uninsured United Parachute Technologies ILC.

RSL-SIGMA SPLIT MODIFICATION

Fig 2E

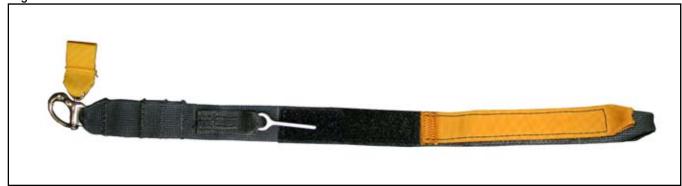
Line up folded edge of secondary gold loop, with raw edge of pile Velcro, and install 3 bartacks. There should be a 1/2" offset between both loop ends as shown.

Bartack over folded edge should step off.

Notice Tyvec label underneath gold secondary loop, and in between both loops.

View of RSL with secondary loop after completed.

Fig 3A

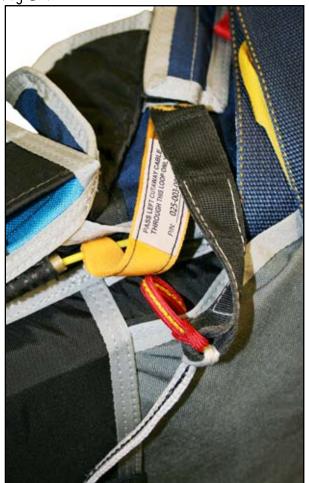
3 different views of installed RSL on a standard Sigma Tandem.

Notice how the left side cutaway cable is passing ONLY through the Gold Loop, and the black I" type 4 has both the RSL pin, and Skyhook lanyard larks-headed on the end Step 3 - Fig3B
